Work Order ID 143762

Item ID: D3391-025 Accept ***N900040100*** Setup Start ***NS1***
Revision ID: Stop ***NS2***
Item Name: Aft Tube Assembly
Start Date: 3/28/2016 Start Qty: 1.00 ***1*** Cust Item ID:
Required Date: 4/29/2016 Req'd Qty: 1.00 ***1*** Customer:
Reference:

Draw Nbr	Revision Nbr	
D3391	<u>J</u>	<u>per ECN 15-516 4/16/5/14</u>

D3391-041/-043 FLOAT SKIDTUBE ASSEMBLY PARTS LIST

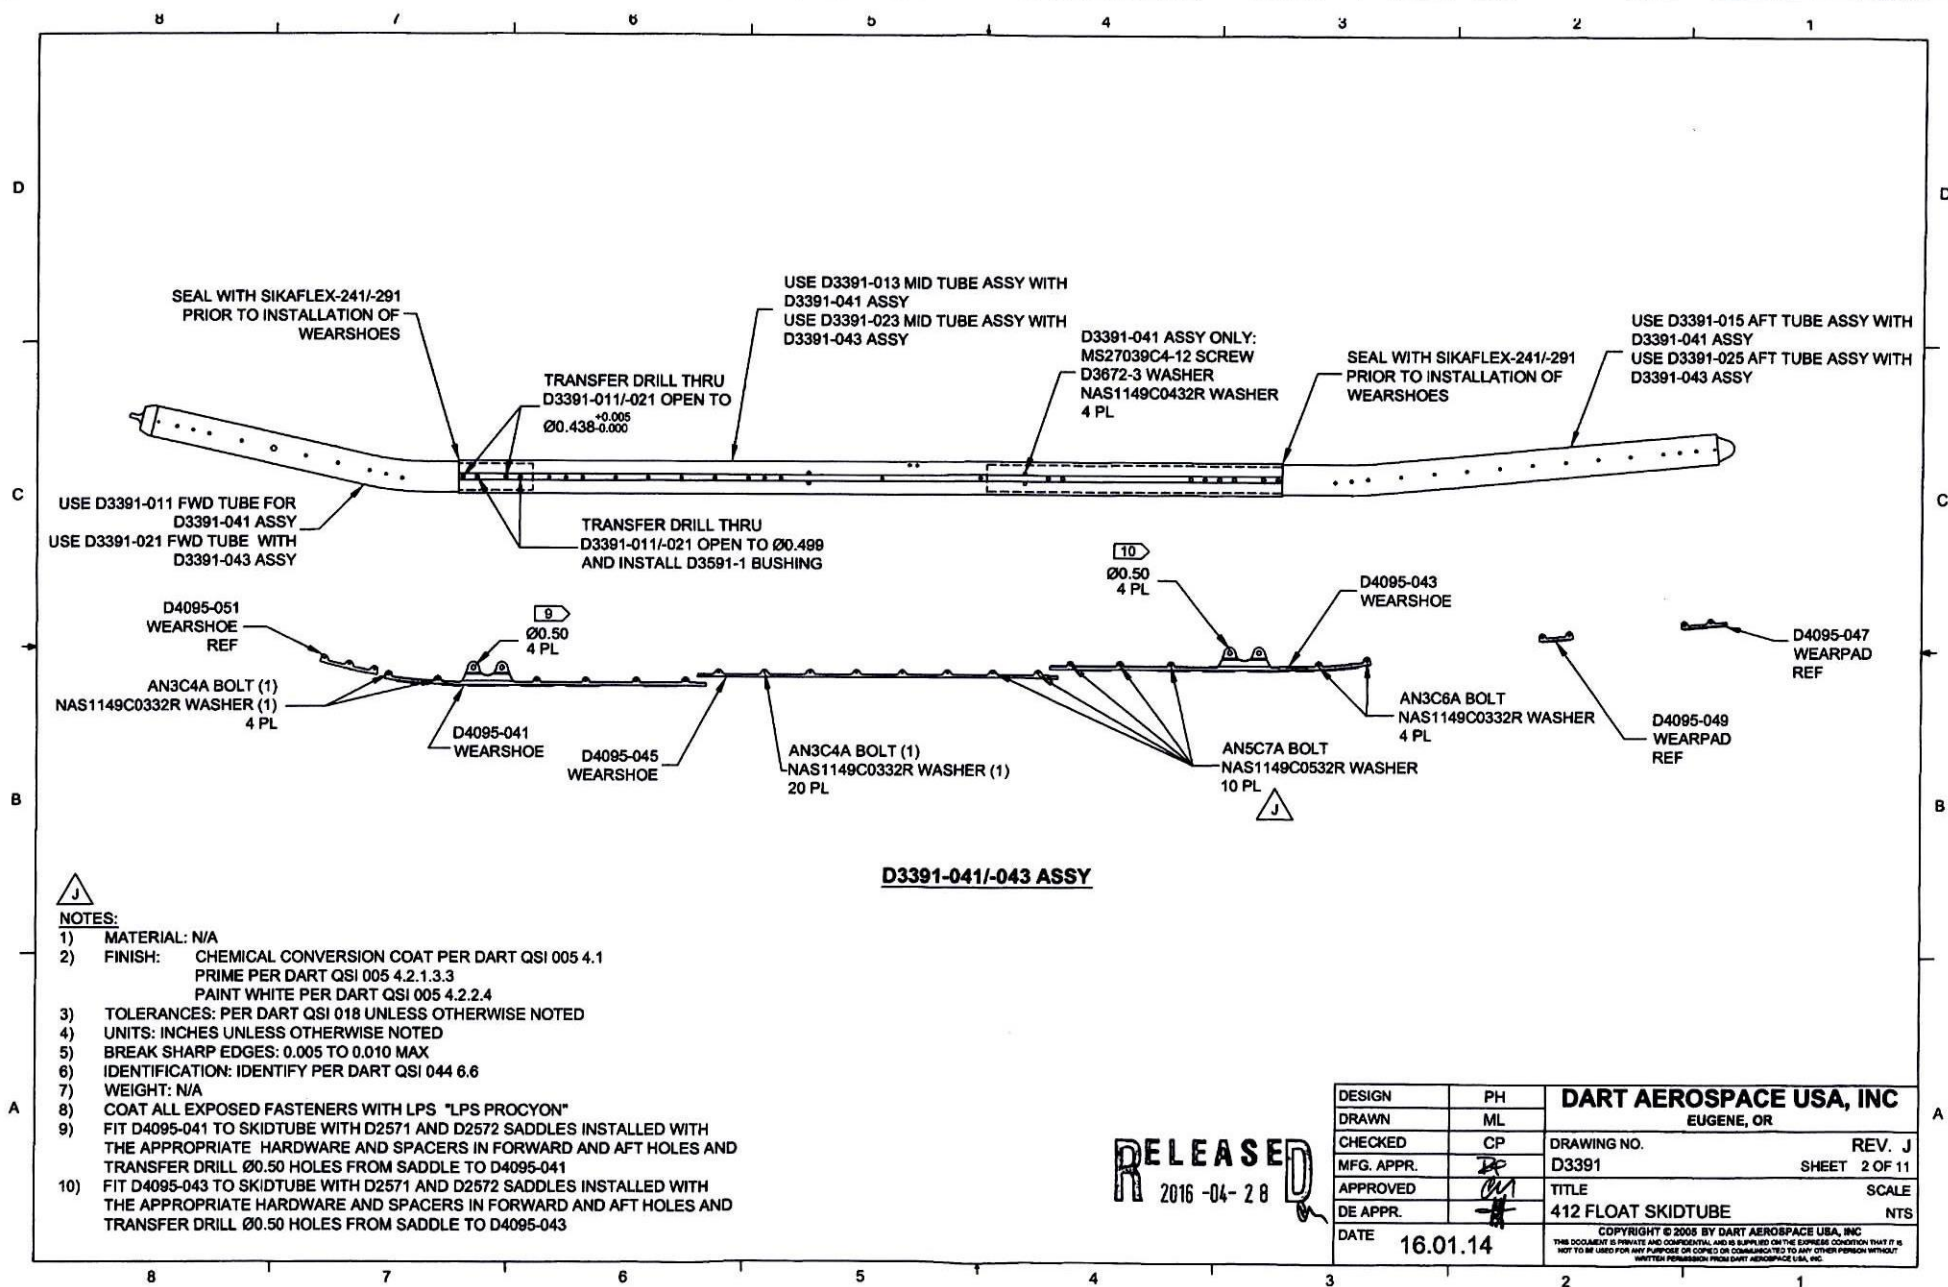
J	INCORPORATED DSI 9733, REFORMAT DRAWING CHANGED CBORE DEPTH (ZN D2-8, D2-9), REVISED TABLES, REPLACED POWDER COAT WITH PAINT	ML	16.01.14
I	REMOVE GASKETS AND REPLACE ALL WEARSHOES; PARTS LIST UPDATE, ZN A8-1, ZN A8-2, ZN A8-4, ZN B8-8; LPS-3 COATING REMOVED FROM NOTE 2, ZN A3-1, ZN A3-2, REMOVED INSERT AELS-1032-130, ZN B6-4, B2-4, C7-8, C3-8; REMOVED HOLES, ZN D6-4 ZN D2-4, ZN D7-8, ZN D3-8	XDF	11.10.13
H	DRAWING UPDATED TO CURRENT STANDARDS. SHT 1 PL ADDED D3591-1 BUSHING. ZN C6 Ø0.438 DIM WAS 4 PL. ADDED Ø0.499 DIM AND D3591-1 BUSHING. SHT 2 PL ADDED D3591-1 BUSHING. ZN C6 Ø0.438 DIM WAS 4 PL. ADDED Ø0.499 DIM AND D3591-1 BUSHING. (FOR FURTHER INFO SEE DSI 9384 & NCR 08-074)	AJS	08.08.20
G	REPLACE NAS INSERTS W/ AELS INSERTS SWITCH TO D3670-XXXX SPACERS FOR INSTALLING FLOAT BAGS, DWG REORGANIZED FOR CLARITY	DC	07.07.31
F	ADD SS WEARSHOE, GASKET REMOVE FWD SADDLE HOLE -011/-021	PH	07.01.18

FIGURE 1 - AFFECTED LOCATIONS
(Aft section of D412-742-XXX Assy shown)

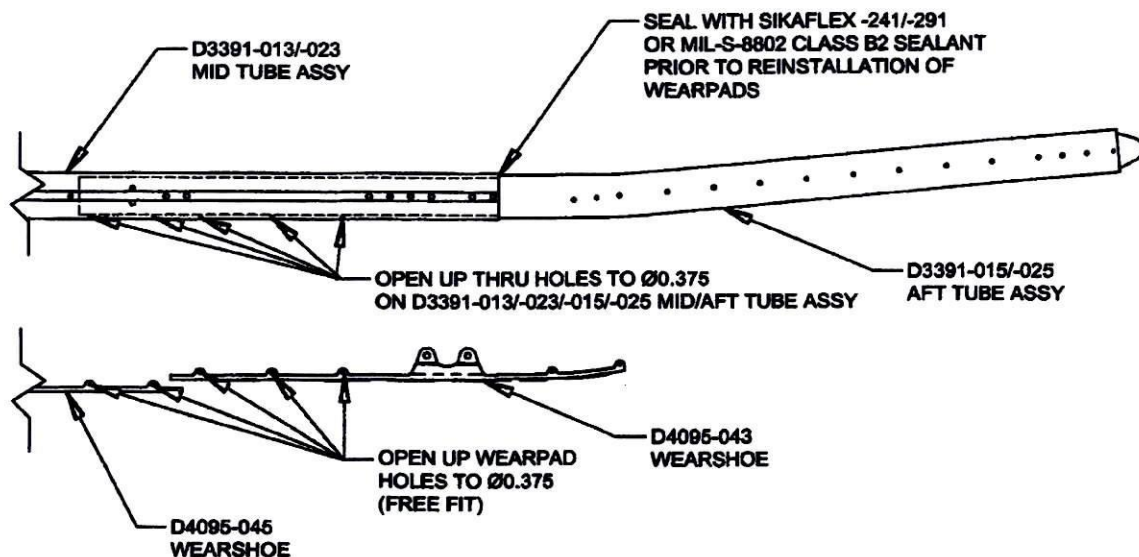
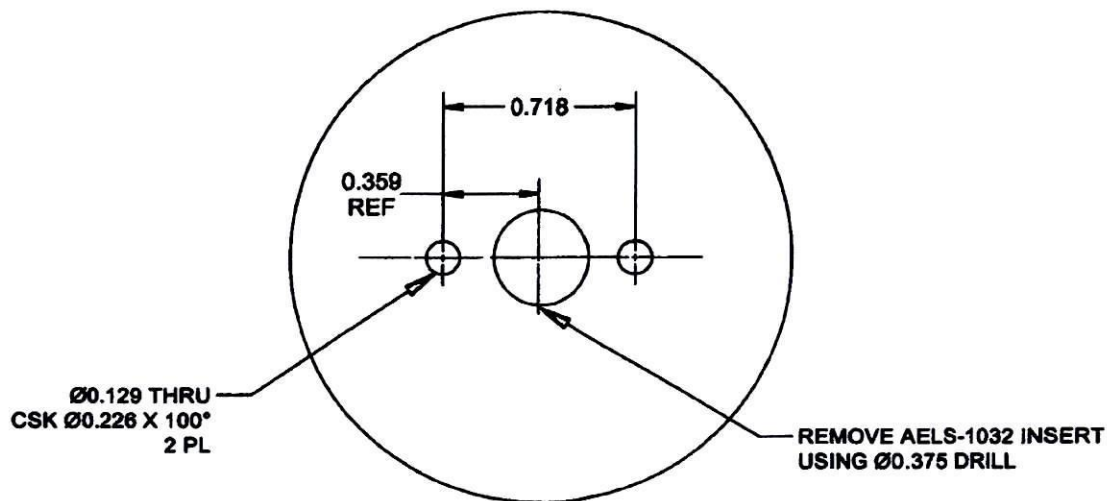
The purpose of this DART Service Instruction is to provide a repair procedure to replace spinning AELS-1032 inserts with MS21075L5 Floating Nut Plates on D412-742-011/-013 Float Skid tubes in locations where the D3391-013/-023 Mid Tube Assembly overlaps the D3391-015/-025 Aft Tube Assembly as shown in Figure 1.

- 2.1 Drill out AELS-1032 Inserts (Qty 10) located in D3391-015/-025 Aft Tube Assembly using a $\varnothing 0.375$ drill in locations shown in Figure 1. With reference to Note 2, add additional $\varnothing 0.129$ countersunk holes (Qty 2) per Detail A.

- 2.2 Increase the diameter of affected thru holes in D3391-013/-023 Mid Tube Assembly with a $\varnothing 0.375$ drill bit, as shown in Figure 1.
- 2.3 Touch up affected areas with chemical film material (Alodine 1200 or 1201) per MIL-C-5541.

- 2.4 Install MS21075L5 Nut Plate (Qty 10) using MS20601AD4W4 (Qty 12) in the six (6) most forward holes and MS20601AD4W9 (Qty 8) in the four (4) aft holes. It is acceptable to replace MS20601AD4 rivets with longer or shorter rivets as required.

- 2.5 Increase diameter of affected wearpad holes on D4095-043/-045 to $\varnothing 0.375$
- 2.6 Re-install D3391-015/-025 Aft Tube Assembly in accordance with ICA-D412-742 Section 32.9. Install D4095-043/-045 Wearshoes using AN5C7A Bolts (Qty 10) and NAS1149C0532R Washers (Qty 10) in locations corresponding to this modification.
